JUSTIFICATION
BAKE HOUSE RECONSTRUCTION

The drawings below serve as a comparison between the original bake house rear elevation, the approved scheme and the re-constructed building.

BAKE HOUSE - PARAPET AND SECRET GUTTER

CORKSCREW WINDER STAIRCASE

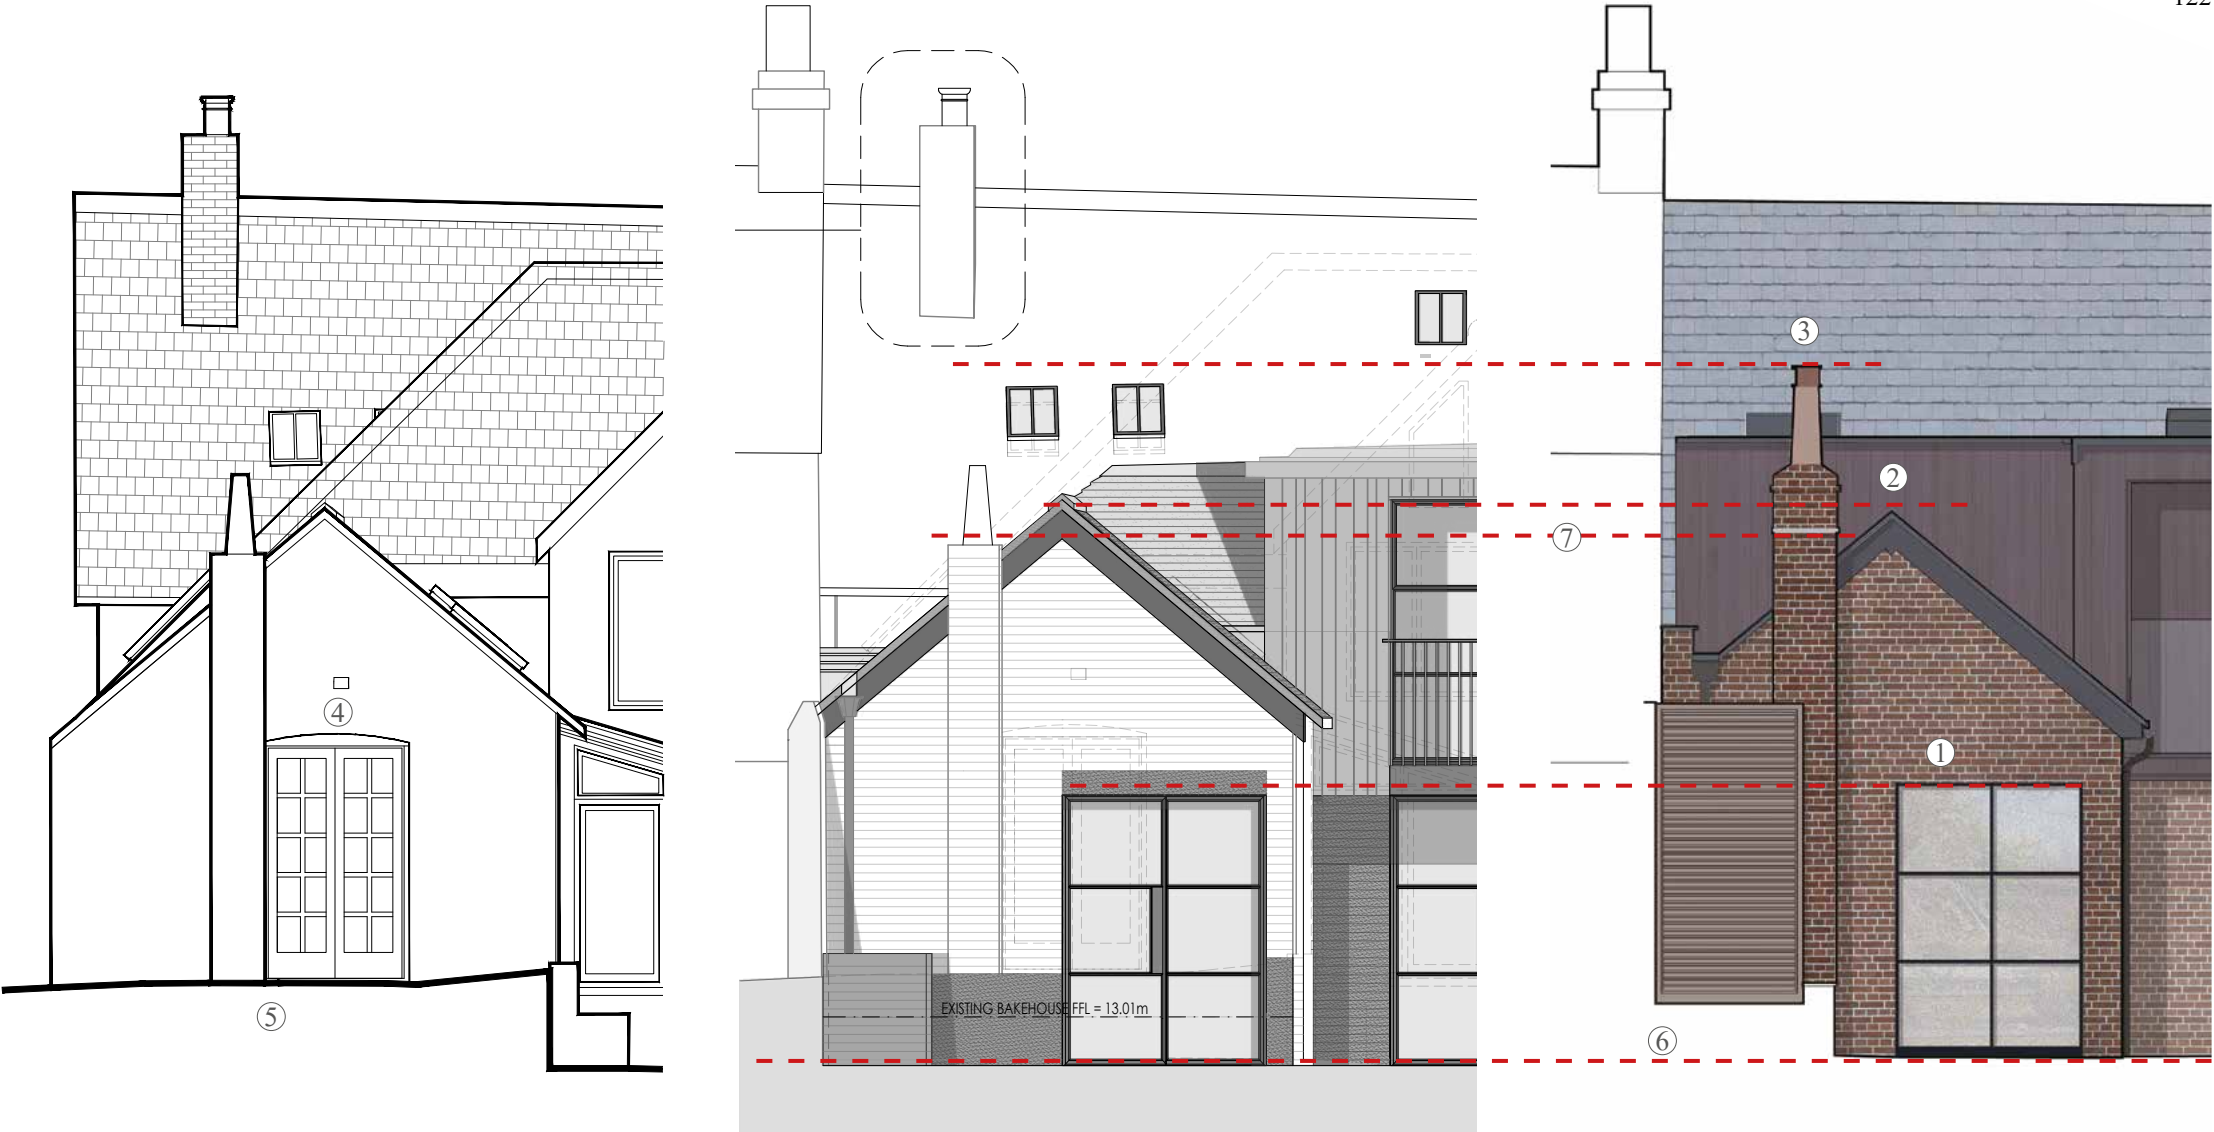
Reconstructed to imitate the historic building in its size, mass, and overall appearance, the bakehouse features openings and a chimney height that vary from the approved scheme.

Located at the rear elevation of the bakehouse the original chimney comprised of brickwork with a single terracotta chimney pot. This character has been retained in the ‘as-built’ house. The ‘as-built’ chimney stack deviates from the approved scheme in height. The clay chimney pot is capped.

The opening on the eastern elevation follows the approved design with a Crittall-style frame and partitioning. It is taller than the approved version, extending to floor-to-ceiling height, while maintaining the original datum, as shown in the adjacent drawing. The proposed opening features a more refined, contemporary design compared to the approved version. This design decision was inspired by local precedence of similar bake house conversion with large glazing additions - refer to Doodie Start photograph on the right.

Following the collapse of the original bake house, the newly constructed chimney was suitably weathered. The clay pot cover that stops nature and wildlife from getting in the chimney while still allowing ventilation to prevent damp.

2. Approved rear elevation - submitted drawings under application DM/22/3694 & DM/22/3695 (planning approved).

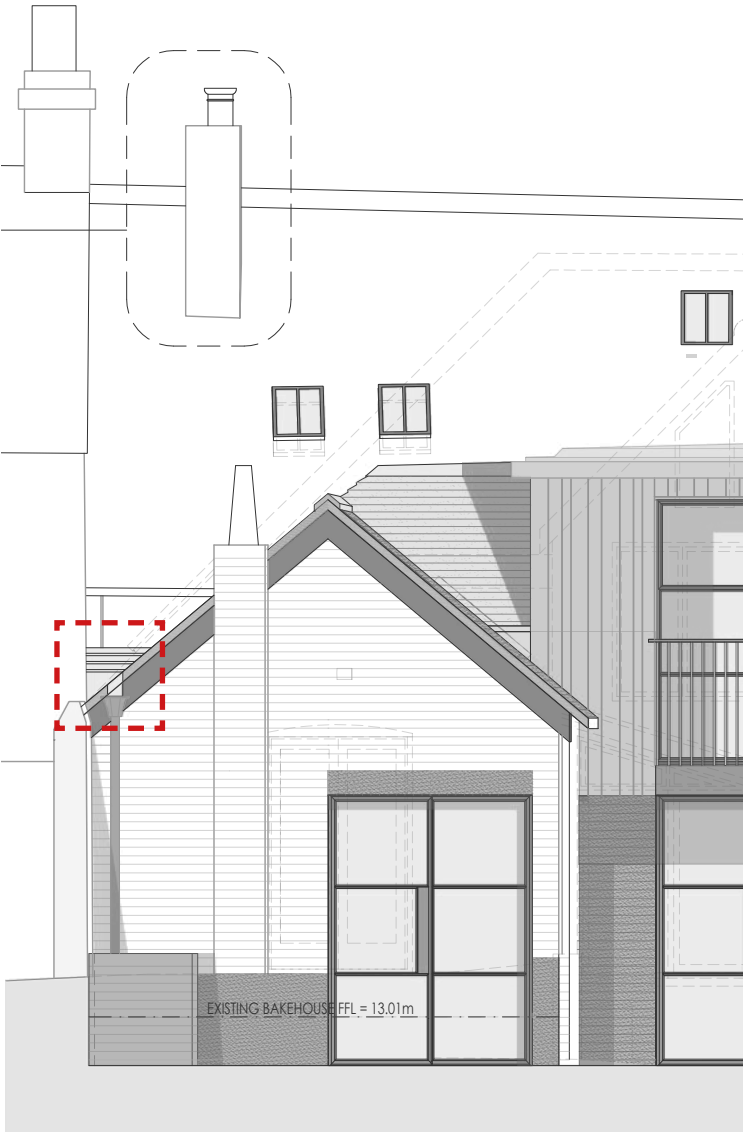
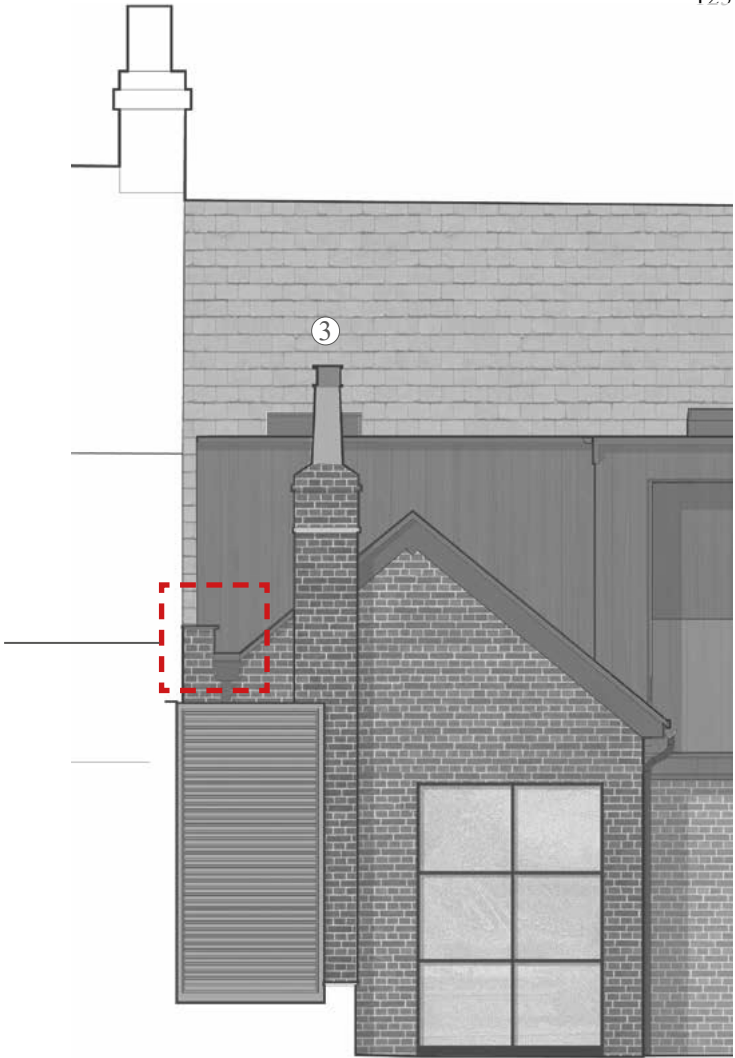
Another difference between the approved and constructed bake house is introduction of parapet wall and secret gutter to the northern side of the building, applied for retrospective planning permission under this application.

Previous drainage solution included a plastic half round gutter located on the bake house Northern wall and discharging rain water into the neighbouring property courtyard. This solution was not suitable for the occasional heavy rain fall and was an ongoing issue with the owner of the property at 109 High Street. This has now been resolved with a far more practical solution of the secret gutter. Additionally, the raised roof of the bake house also benefits from the secret gutter detail as the rain flow on this elevation is now designed to cope with the volume of rain being dispersed and not contribute the overflow of water into neighbouring premises.

A parapet gutter, situated behind parapet walls, offers several benefits, as expanded on below:

Section AA - proposed reinstatement of staircase on ground and first floor

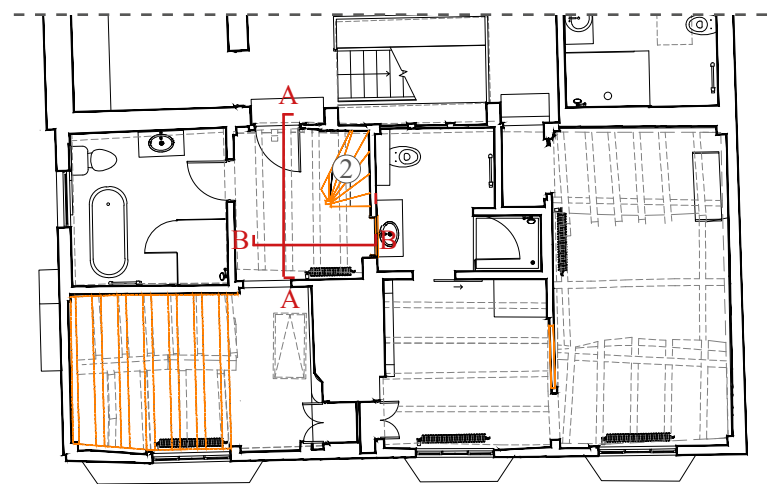
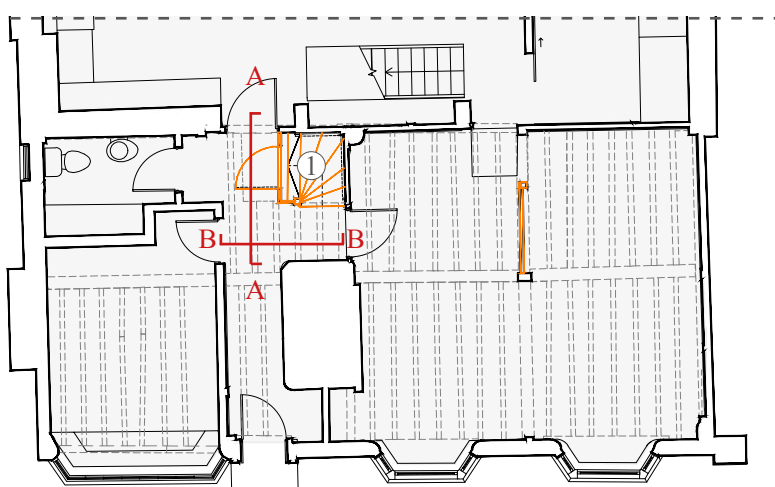
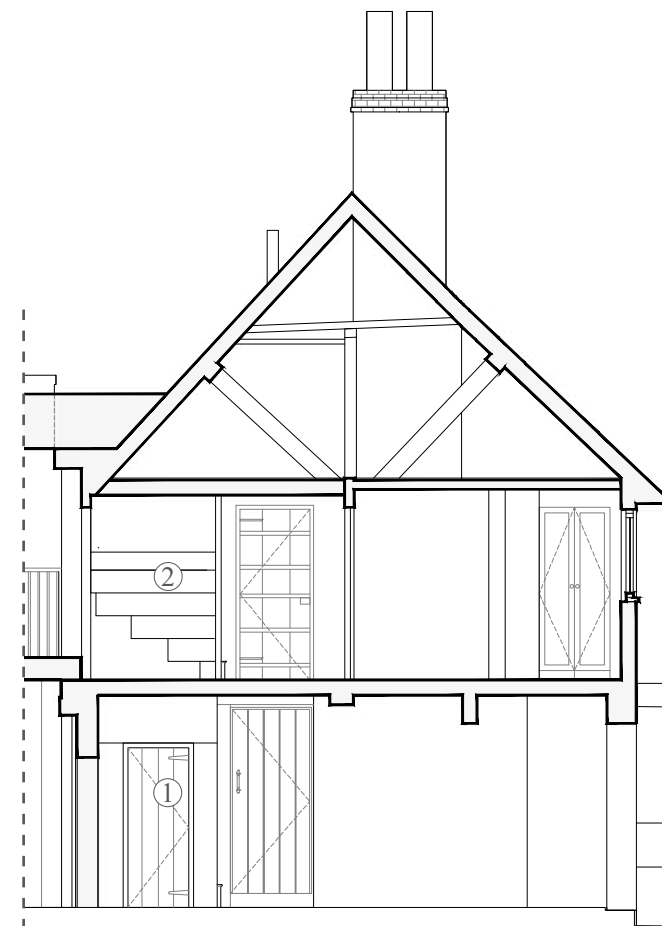
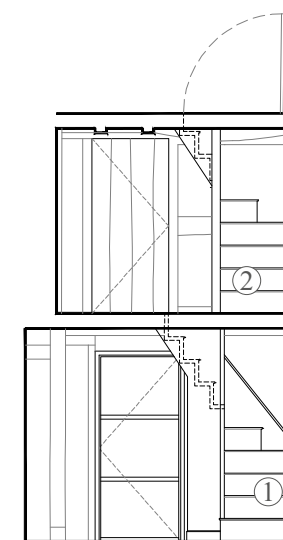
The historic, 17th century timber corkscrew winder staircase of historic value has been removed due to confusion arising in the approved drawings and conflicting information contained within them.

It is therefore proposed that the staircase will be reinstated on ground and first floor, as follows:

1. Ground to first floor staircase - staircase to be reinstated, oak timber steps to closely resemble original, stringer to be reinstated. Refer to the proposed drawings for further details. Timber joinery enclosure and basement access door to be reinstated.

2. First to second floor staircase - staircase to be reinstated. Some sections of salvaged timber to be used. The plans show this removed and there is no condition requiring retention and as a measure of good faith it is proposed to be reinstated together with opening above allowing for attic access - to be enclosed with access hatch. Refer to the proposed drawings for further details.

The proposed reinstated staircase is to be reconstructed as close to the original as possible, given the limited information of the historic condition.

As the staircase is to take form of the original one, it will not be suitable for regular use due to its steepness and limited step depth. Instead, it will most likely serve as a decorative feature that acknowledges the historic fabric of the building, while a new staircase in the living room, compliant with current building regulations, will provide the functional connection between levels.

2. Proposed attic plan

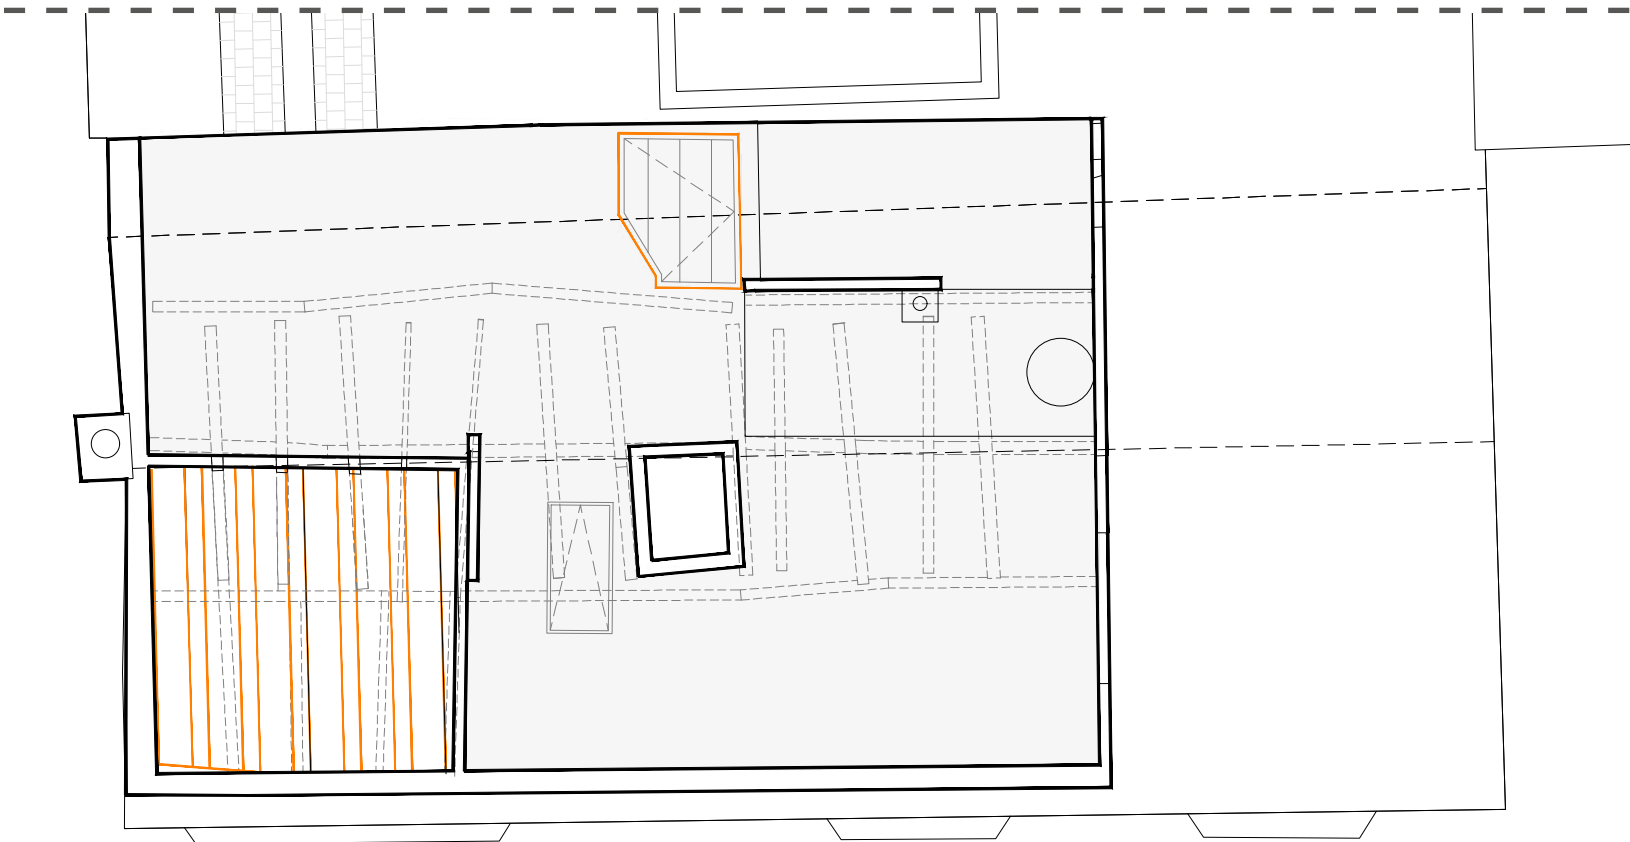
The staircase connecting first floor with the attic has been removed. Its removal was approved under planning application DM/22/3694. Approved attic plan GH342 PL.04A clearly states its removal. Refer to the adjacent drawing and key.

As previously discussed, as a measure of good will the staircase linking first floor with attic will be reinstated and a new access hatch will be introduced on attic level. Oak timber planks to be used for its construction on the floor finish level. Refer to the proposed drawings for further details.

2. Proposed ground floor plan

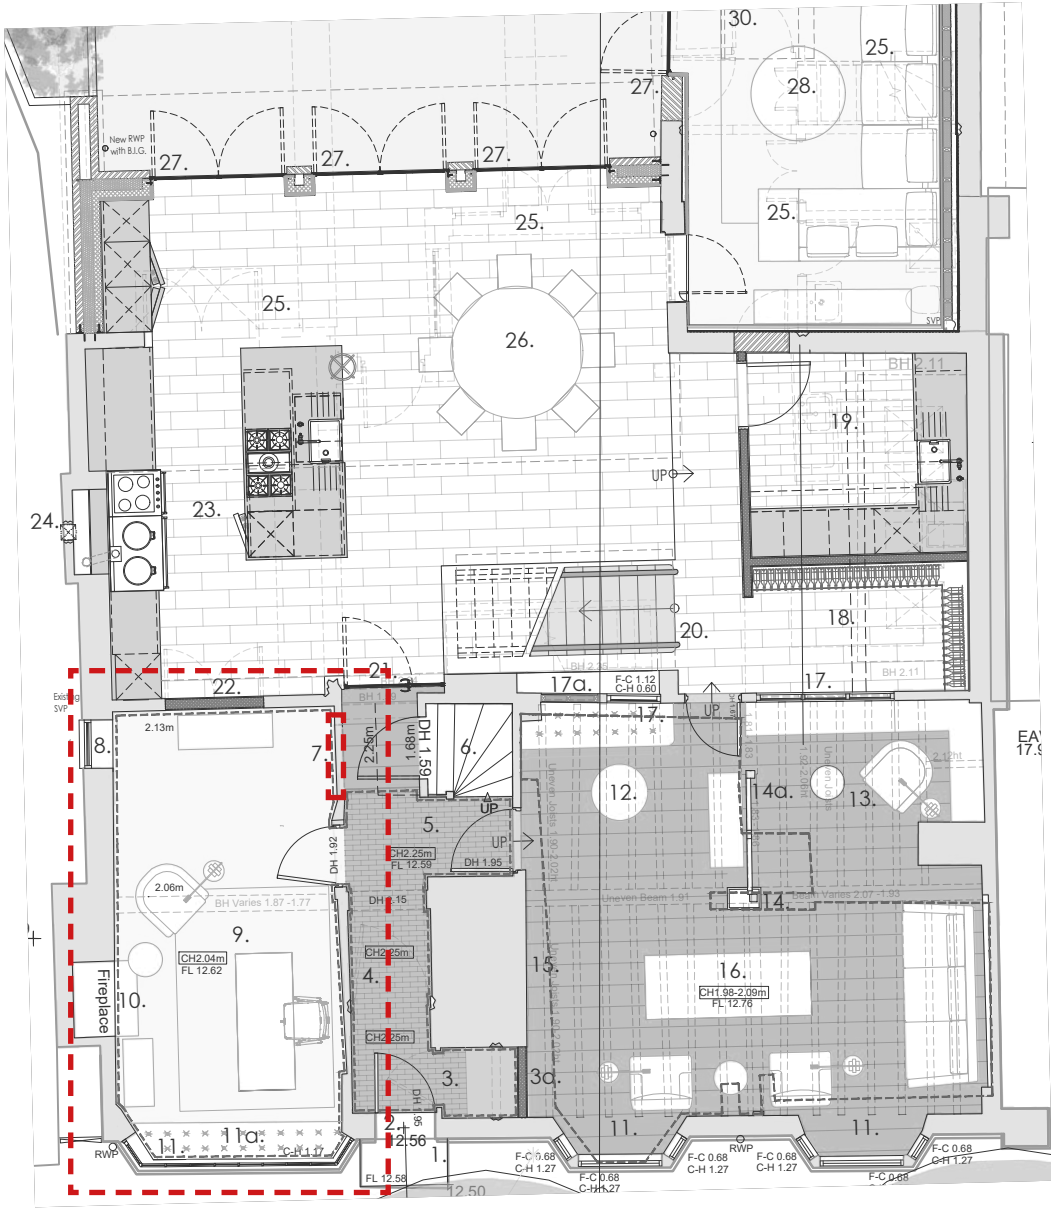
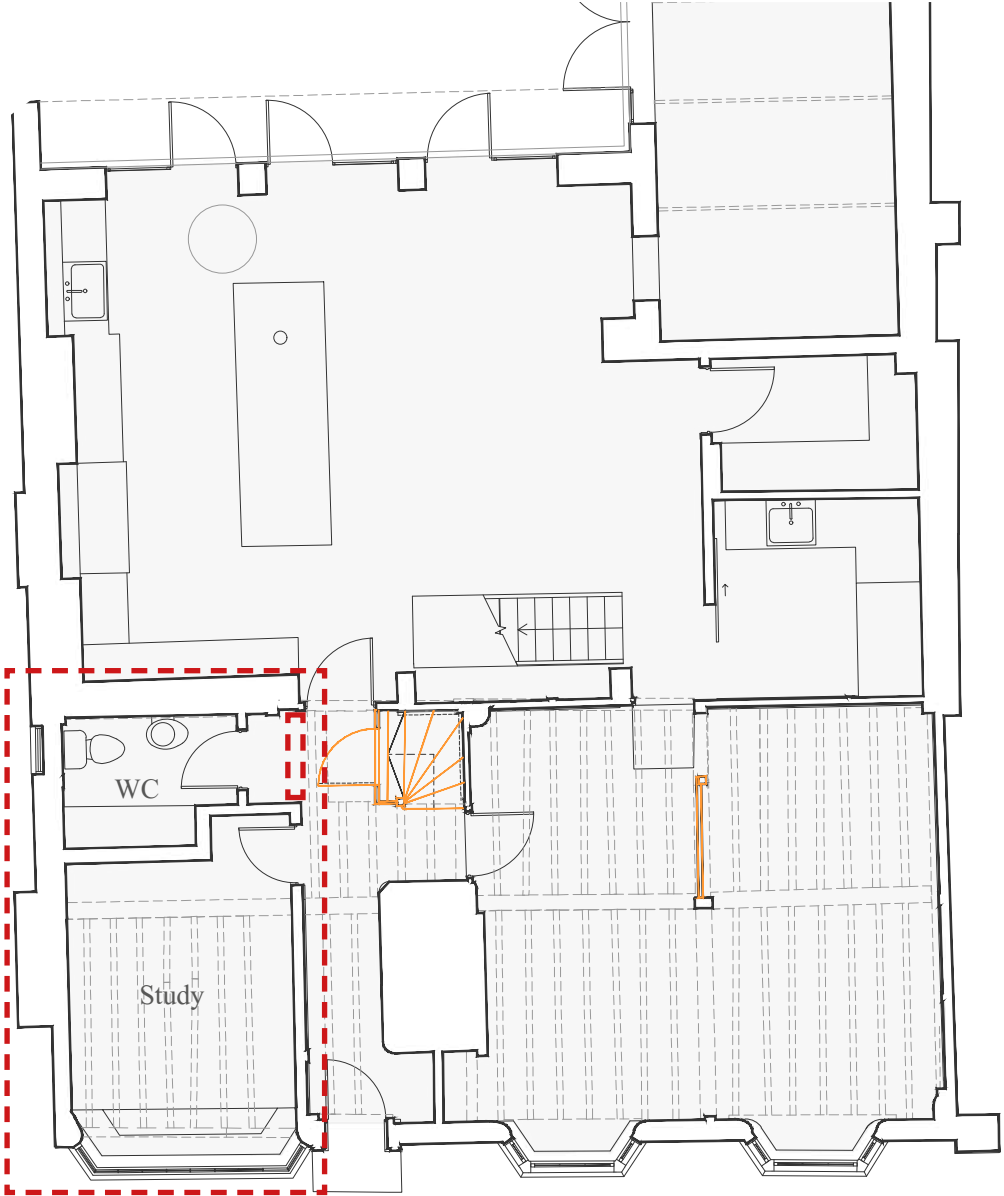
A partition wall was constructed in the southern part of the ground floor plan to accommodate a new ground floor WC. Furthermore, a timber stud wall with stone veneered nogging at ground level was removed to create a reveal / recessed entrance to WC. This part of the wall was not original and consisted of breeze blocks and modern stone nogging (refer to photograph below and HCUK Heritage Report). In their report HCUK assessed this as follows: *‘It appears not to have been an original wall or historical feature, as demonstrated by the presence of concrete blockwork within the wall uncovered during its removal. The demolition of this partition to create a reveal / recessed cloakroom at the entrance to the ground floor WC improves circulation and layout without harming significance. The impact of this change on the listed building’s significance would be a minor heritage benefit as the wall was misleading and interruptive of historic plan form.’*

This is a deviation from the approved scheme and is part of the retrospective works that this application applies for.

The location of the study door is in the historic position and the legibility of this opening has therefore been retained. Within the study, there is evidence in the oak frame overhead that there used to be a lateral partition (that has since been removed unlawfully by previous tenants). Whilst the new partition has been located away from this location, it is still suggestive of the historic and secular plan form of the historic core of the house and should be regarded as acceptable.
